**Dewey-Burdock Project
Application for NRC
Uranium Recovery License
Fall River and Custer Counties,
South Dakota**

Technical Report RAI Responses

June 2011

Figure 3.2-5

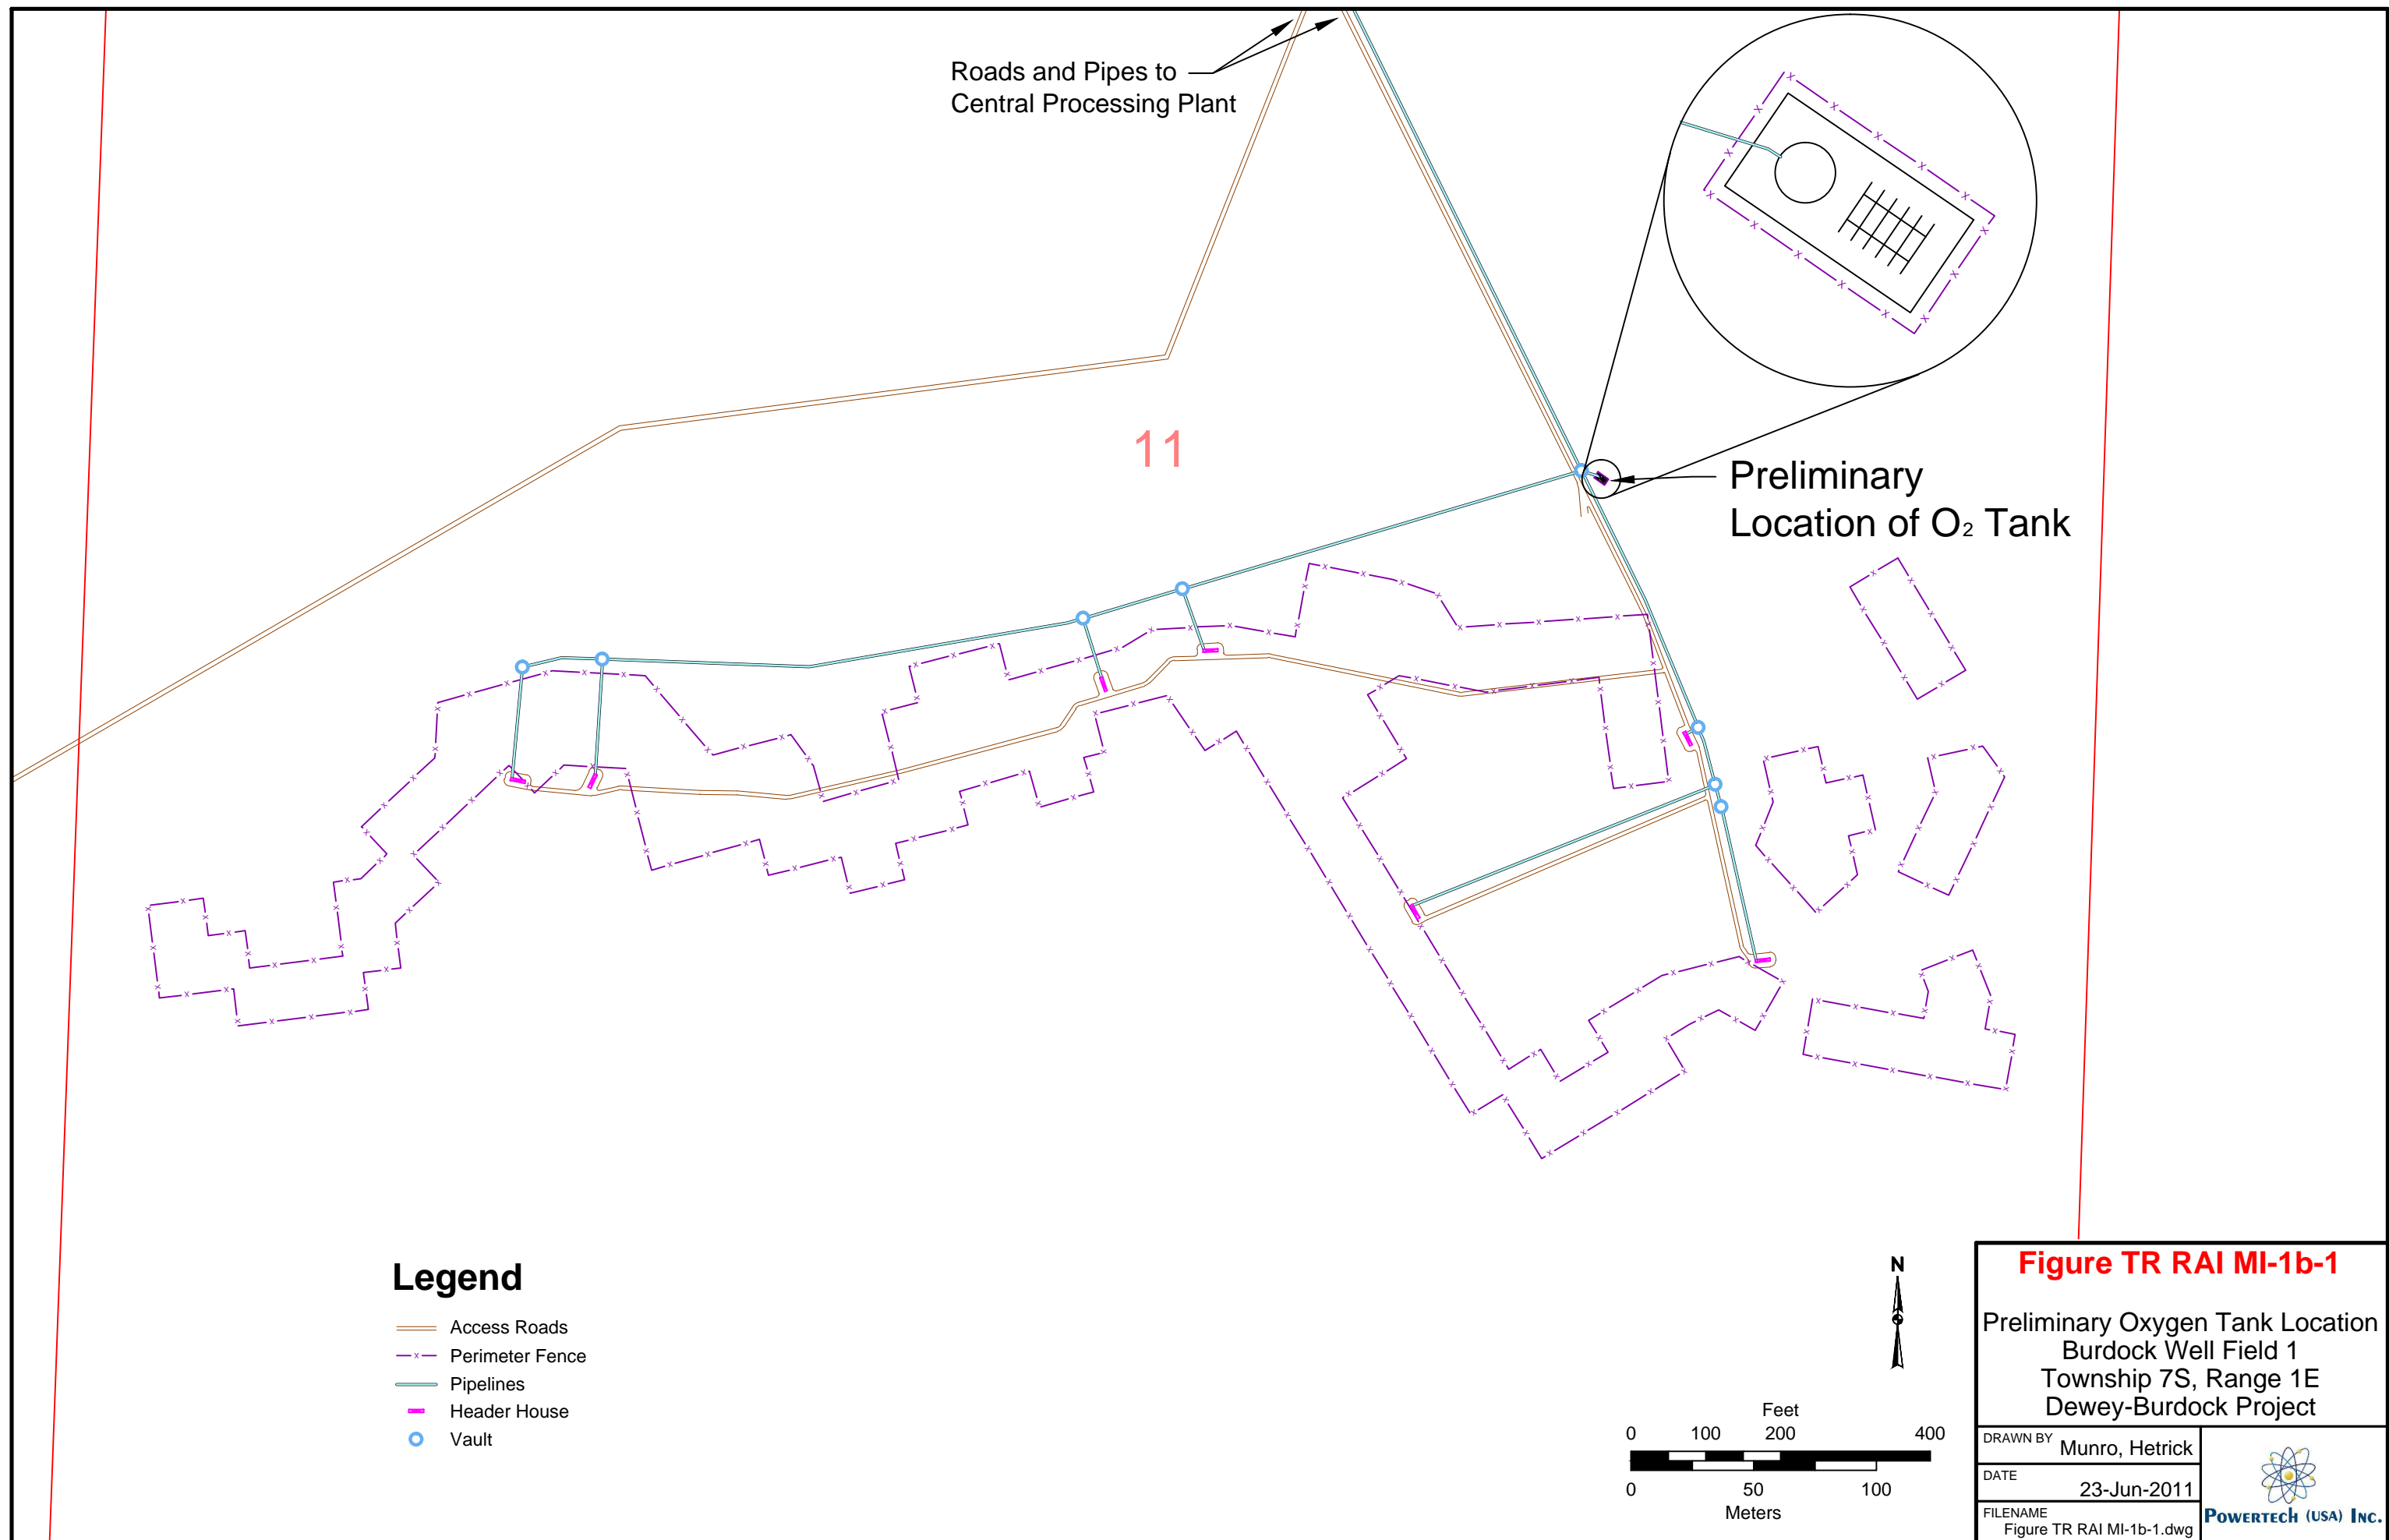
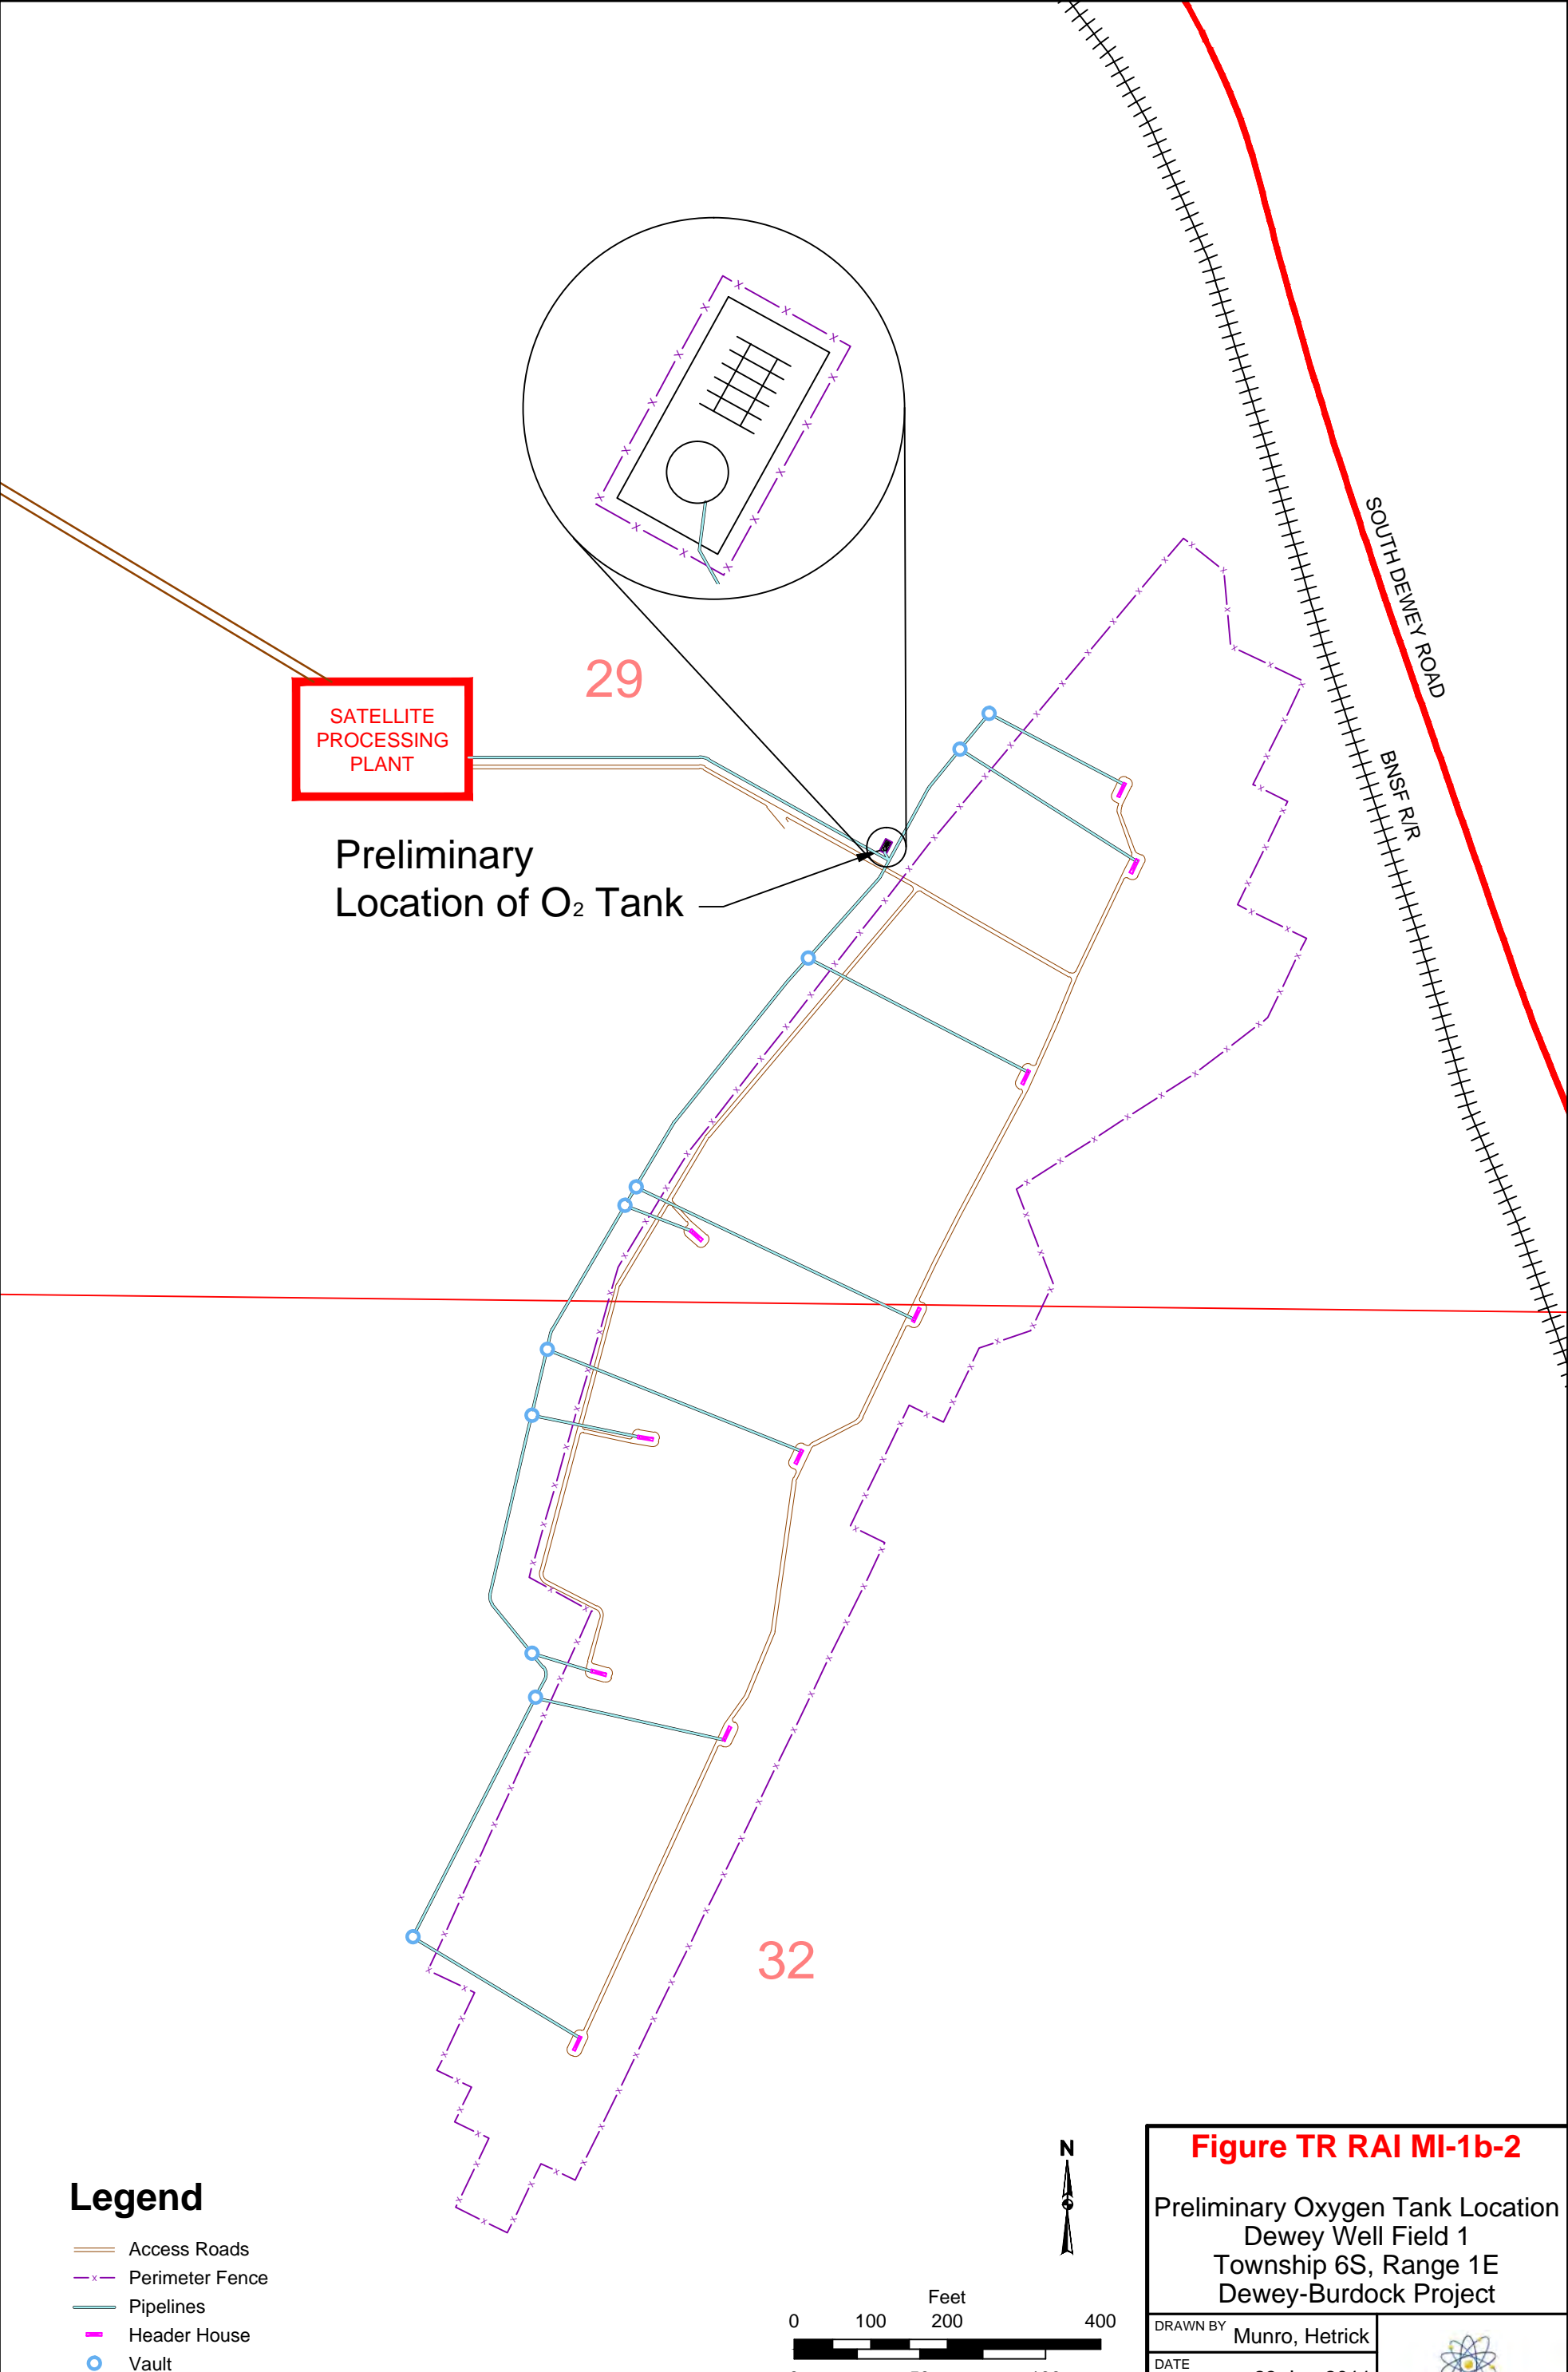
- b. The applicant needs to completely and clearly identify on Figures 3.2-4 and 3.2-5 the storage locations of all chemicals used in uranium processing (enlarge figure to be readable). The locations need to be consistent with the descriptions of chemical use provided in Section 3.2.8 of the application.***

TR Figures 3.2-4 and 3.2-5 have been revised and enlarged to show the storage locations of all chemicals used in uranium processing, with the exception of oxygen. The revised figures are included with this response package and also will be included in the revised TR. For a list of chemicals, refer to Table TR RAI MI-1a-1 provided in the response to TR RAI MI-1(a). Barium chloride will be stored as palletized sacks at the locations shown on Figures 3.2-4 and 3.2-5. Oxygen will be stored as cryogenic liquid in tanks located in the well field areas. Oxygen storage tanks will be located near but at a safe distance from header houses as required by NFPA and OSHA standards. Figures TR RAI MI-1b-1 and TR RAI MI-1b-2 depict the potential oxygen storage tank locations for the Burdock and Dewey initial well fields, respectively. Please refer to the response to TR RAI MI-1(a) for additional information about the safe storage of oxygen.
